# Access Compliance Report

## Public Rights-of-Way

Intersection ID: N/A	Main Street: S_BREVARD_ST	Cross Street: E_4TH_ST	Location: SE
ADA ID: 058DE96C9959	Ramp Type: PerpDiag	Initial Pass/Fail: Fail	Overall Compliance: No
Severity Score: 12.5			
Codes/Mitigation Info/Possible Solution		Field Measurements/Component Compliance

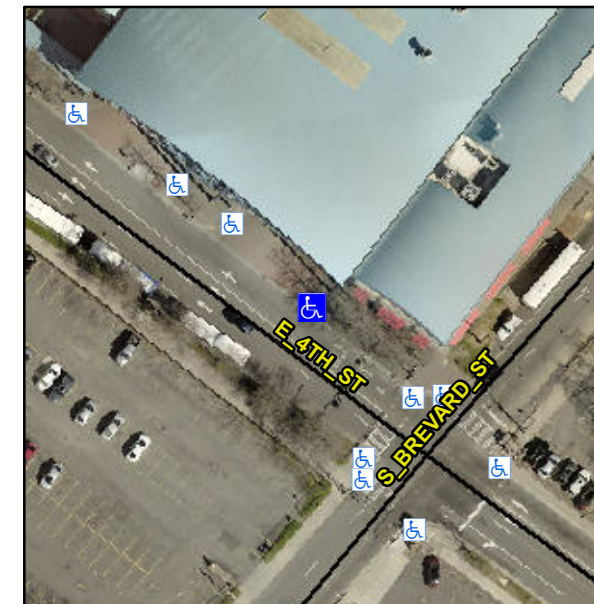
Compliance	Description	Data	Compliance	Description	Data
N/A	Ramp Length (in)	96.0	No	Ramp Slope (%)	8.7
Yes	Ramp Width (in)	48.0	Yes	Ramp XSlope (%)	0.2
N/A	Flare Type LT	N/A	N/A	Flare Type RT	N/A
N/A	Flare Slope LT (%)	N/A	N/A	Flare Slope RT (%)	N/A
N/A	Flare Traversable LT?	N/A	N/A	Flare Traversable RT?	N/A
N/A	Landing Length (in)	N/A	N/A	DWS Provided?	N/A
N/A	Landing Width (in)	N/A	N/A	DWS Contrast?	N/A
N/A	Landing Slope (%)	N/A	N/A	DWS Length (in)	N/A
N/A	Landing X Slope (%)	N/A	N/A	DWS Full Width?	N/A
N/A	Landing Curb? (Y/N)	N/A	N/A	DWS Offset (in)	N/A
N/A	Shared Landing?	N/A			
N/A	Gutter Ponding?	N/A	N/A	Gutter Slope (%)	N/A
N/A	Gutter Lip Ht (in)	N/A	N/A	Gutter X Slope (%)	N/A
N/A	Painted X Walk1?	No	N/A	Painted X Walk2?	No
	X Walk 1 Direction	To SE		X Walk 2 Direction	To SW
N/A	X Walk 1 Width (in)	N/A	N/A	X Walk 2 Width (in)	N/A
	X Walk 1 Slope (%)	2.9		X Walk 2 Slope (%)	0.7
	X Walk 1 X Slope (%)	1.3		X Walk 2 X Slope (%)	0.7

**Remove & Replace Curb Ramp With Two New Directional Ramps or Equivalent.**
